Thank you for the opportunity to make a public submission on VicGrid's Draft Victoria Transmission Plan (**VTP**). Your process is, for the first time, delivering transparency and rigour to transmission planning in Victoria. You and your team have done prodigious work, but we now risk a last-minute rush to rubber stamp bad legacy projects and lock-in procurement contracts that deliver little benefit to Victoria.

As you know, we have provided a detailed "not for publication" response that includes commercial-in-confidence information. We have also provided project details on Syncline Community Cable (**SCC**), the proposed 265km HV DC underground link between Melbourne and the State's northwest. (Refer: www.synclinecommunitycable.com.au)

Figure 1 - VicGrid's plan for Western Victoria. Projects in red cost \$12.9 Bn and should not be contracted until VicGrid's engineering work is completed. Projects in green should be prioritised⁵

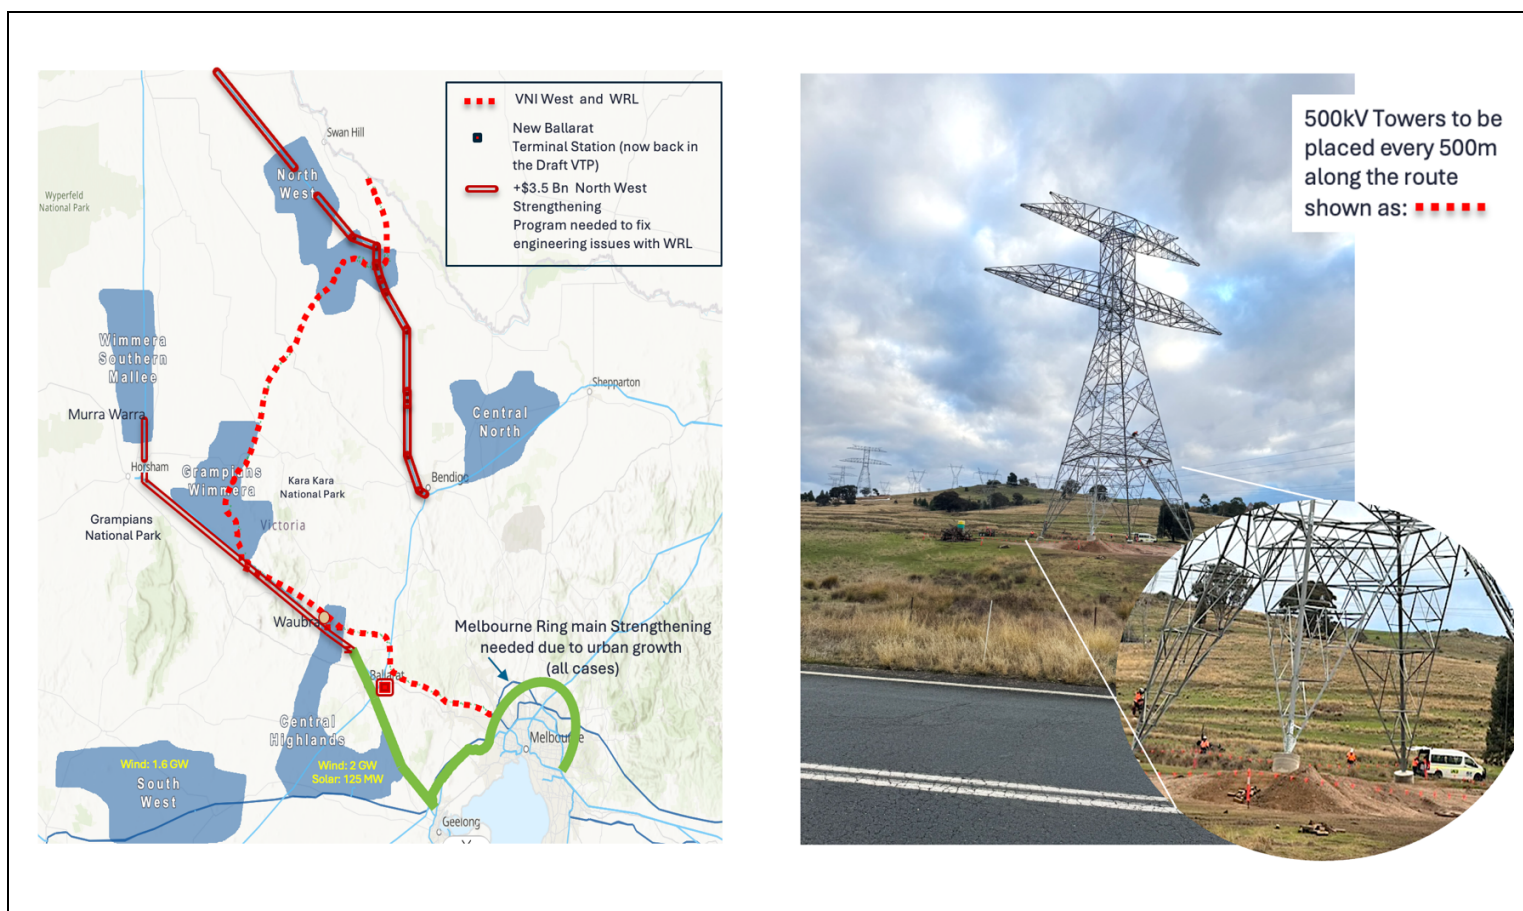
Syncline acknowledges the urgent need to reinforce Victoria's transmission network. The Melbourne Ring Main and re-conductoring out to Ballarat must be prioritised. This will both remove constraints for existing wind farms (e.g. Golden Plains WF) and will support urban growth in the west and east of Melbourne. These projects are shown in green in Figure 1.

In all scenarios, the Melbourne Ring Main and reconductoring out to Ballarat should be urgently progressed. This will both remove constraints for existing wind farms (e.g. Golden Plains WF) and is needed to accommodate urban growth in the west and east of Melbourne. These projects are shown in green in Figure 1 (above) and listed in the Draft VTP Appendix A as Projects 1.1 to 1.4, 2.2 to 2.5, 4.1, 4.3 and 4.4.
